City of Fairfax, Virginia

SUBJECT: Request of Capital City Real Estate for a City Council work session to discuss the redevelopment of 10306 Eaton Place

CITY OF FAIRFAX

Zoning Map Amendment (Z-22-00583)
Special Use Permit (SU-22-00584)
Special Exception (SE-22-00585)

Figure 5: General Development Plan

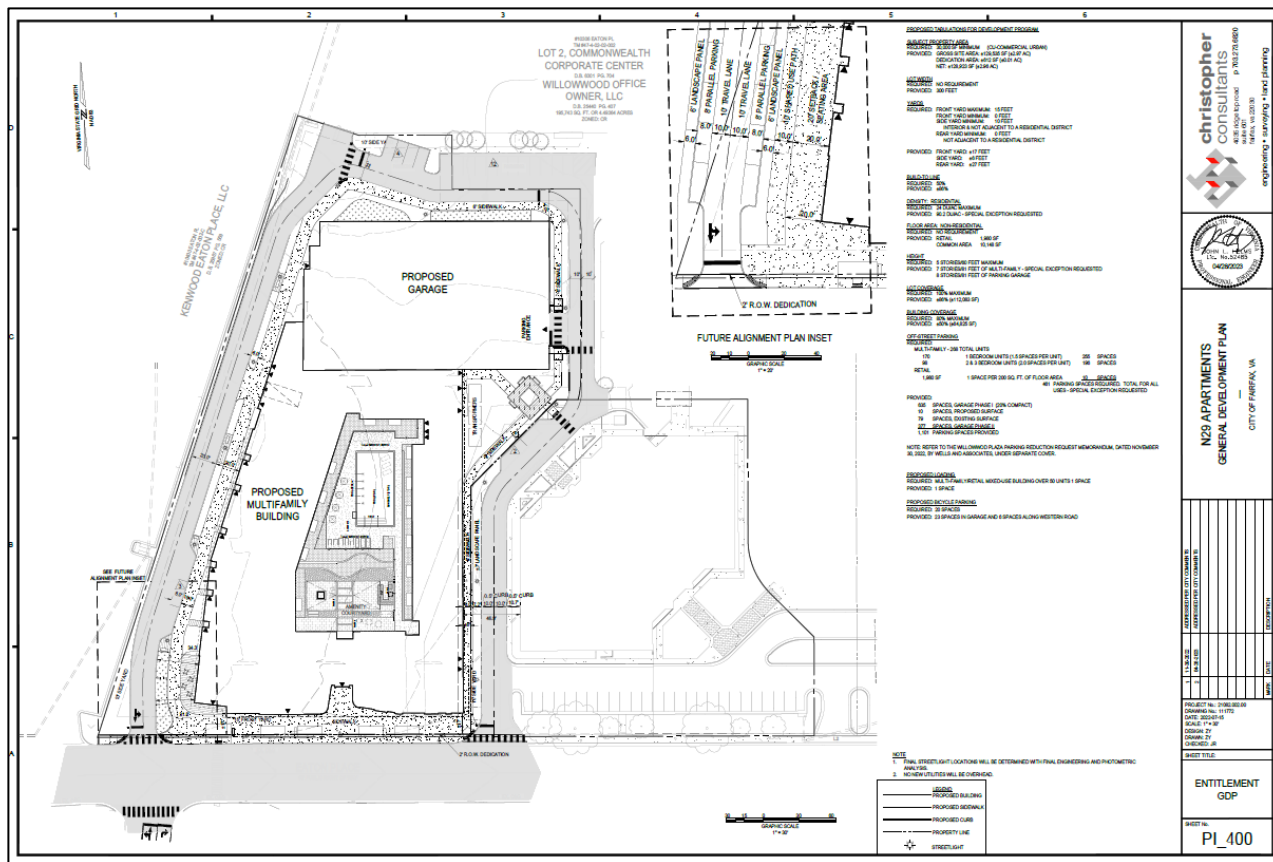
The applicant has proposed Transportation Demand Management (TDM) strategies to help reduce the number of trips generated by the development. The applicant has proposed to provide information on ridesharing, local transit services and carpooling, as well as provide a one-time transit card with a value of twenty-five dollars (\$25.00) per unit at the initial occupancy. The Applicant has proposed on-site bicycle parking area for residents and employees of the building. The applicant has also stated an interest in providing an electric vehicle (EV) charging station on site. The applicant would need to provide the location of any EV stations on the general development plan.

edge of the site and plans to shift the existing curb cut on the western edge to align with the University Drive Extension. The access points are located approximately 285 feet apart (from centerline to centerline). The proposed street on the western edge of the site provides access to an existing two-story parking garage and wraps around the building to provide access to the proposed parking structure for this upper-story residential/mixed use building. The street continues along the eastern edge between the proposed building and the existing office building at 10306 Eaton Place. The proposed street on the western edge has on-street parking to serve the proposed ground floor retail. The proposed western street is 30 feet in width at Eaton Place with 10-foot travel lanes. The roadway width tapers down to 20 feet with 10-foot travel lanes that circulate around the building. The full extent of the streetscape would not be implemented along the new road and the area as designed would be limited for future commercial furnishings.

Additional information is required on the general development plan to help staff evaluate how parking is allocated between residential units and commercial uses. The applicant should identify those spaces on the plan. Staff also recommended that the applicant ensure that the parking dimension standards are following Section 4.2.6 of the Zoning Ordinance. The proposed 50 multifamily units in Phase II (10300 Eaton Place) will be parked at two spaces per unit

Building/Fire Code: The plan needs to show the area between the private roadway and the edge of the building being reinforced to handle the load imposed by the outriggers of Tower Ladder 403. The plans also need to show two (2) Fire Department Connections (FDC) located remotely on the residential building, and two (2) FDCs located remotely on the parking deck. The current design indicates the parking deck has an independent manual dry standpipe system. A fire hydrant must be located within 50 feet of all fire department connections. The use of existing fire hydrants spaced greater than 50 feet should be indicated on the plans for consideration. The applicant will need to submit all turning movements using the correct specifications for the City of Fairfax Tower Ladder 403. Finally, the private roadway will be designated a Fire Lane in its entirety. The required marking specifications are not included in the plans. Continuous curb and surface painting (both sides) and signs must be shown on the plans.

Figure 6: Stormwater Management Plan

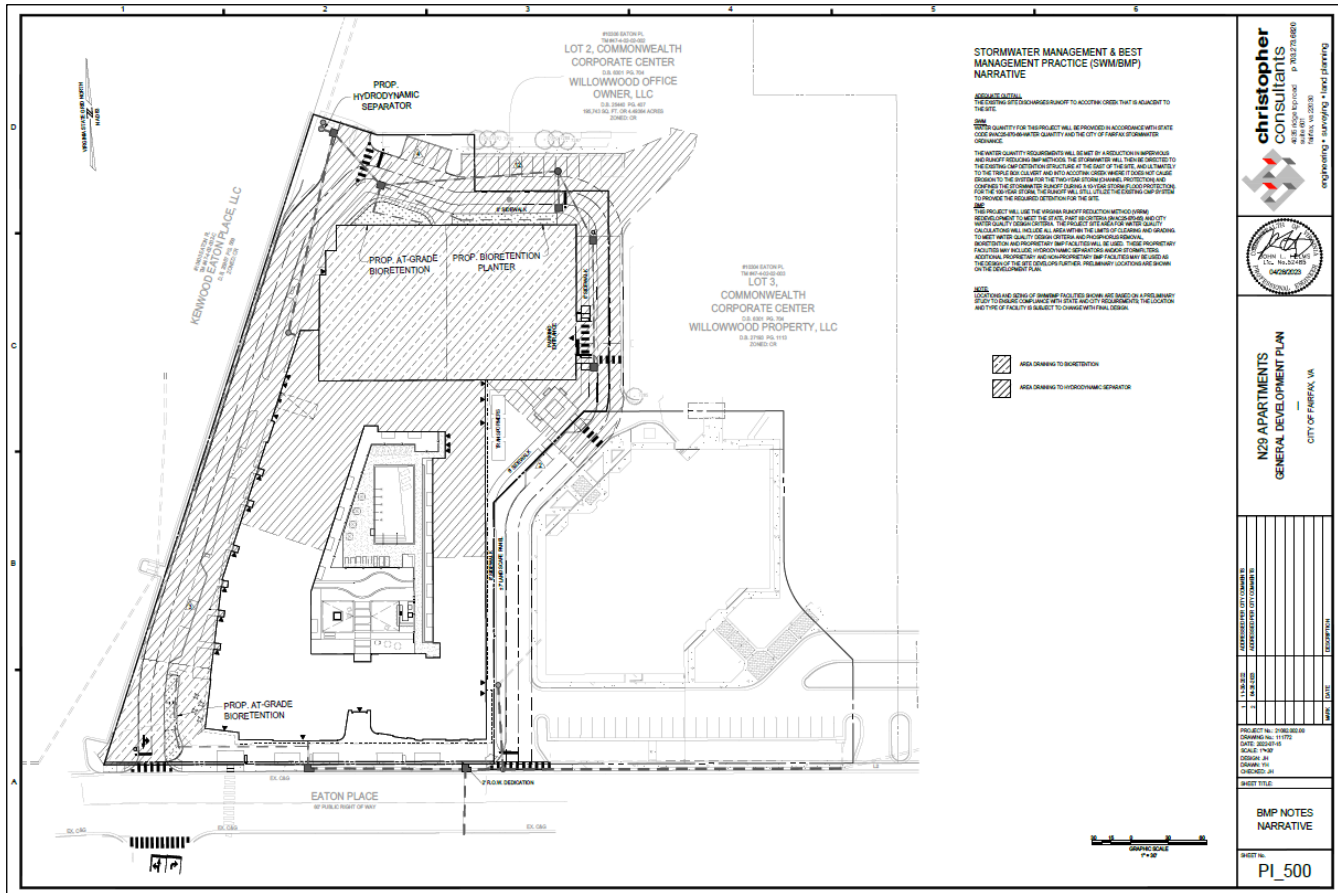
Public Works/Civil: The applicant needs to clarify whether the water quality requirements will be met on-site and as part of this phase of development.
